# 1958 Corvette: Service Bulletin: Electric Windshield Wiper Information

**Subject:** Electric Windshield Wiper Information

**Model and Year:** 1958 Passenger Cars and Trucks

**Bulletin No:** DR #359

FIGURE #1.

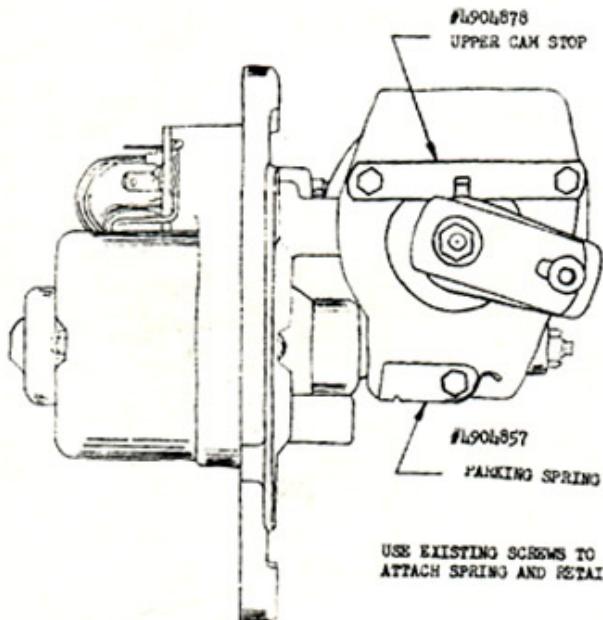
In some cases the wiper motor, after being shut off, may over travel the effective length of the parking cam and continue to run in a reverse direction. This condition may occur even though the blades are properly positioned as covered in TSB #508, DR #359.

A parking spring has been released for production and service which enables the motor to shut off without depending on the resistance of the wiper blades. The spring is designed to clear the revolving arm in the "ON" position and stop the arm in the "PARK" position when switch is turned off. Figure #1 shows installation of parking spring.

If the right hand blade slaps against the moulding excessively even though the blade is correctly positioned and parks properly, the upper cam stop is probably bent or broken. This damage can occur if the mechanism is coated with ice when the wiper is turned on.

A more durable replacement cam stop is available for service. Figure #1 shows details of installation. The existing tab must be bent flat before installation of the new stop.

SKETCH SHOWING INSTALLATION OF PARKING SPRING AND  
CAM STOP ON 1956 ELECTRIC WINDSHIELD WIPERS.

FIGURE 2.

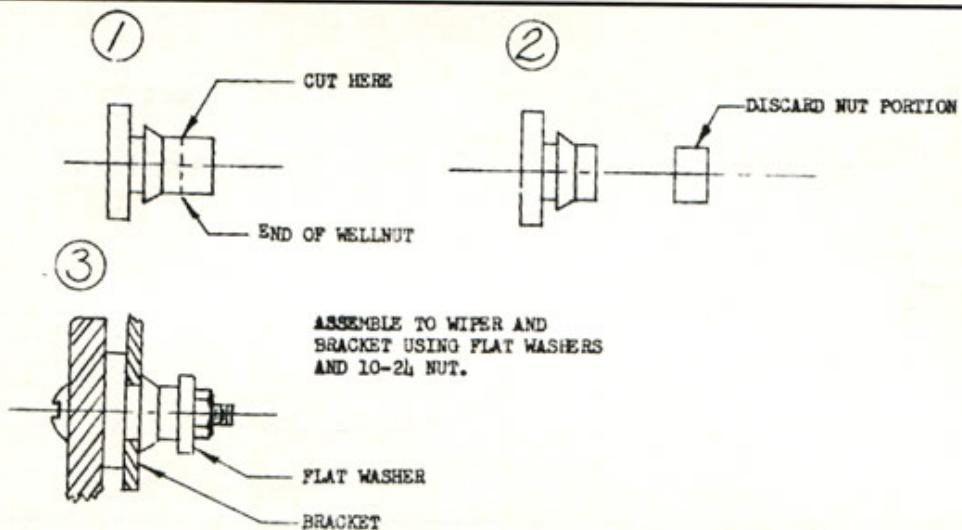
If loosening of the wiper motor on the support bracket or failure of the rubber "Wellnut" attachment is experienced, modify the "Wellnuts" and attach motor to bracket as shown in Figure #2.
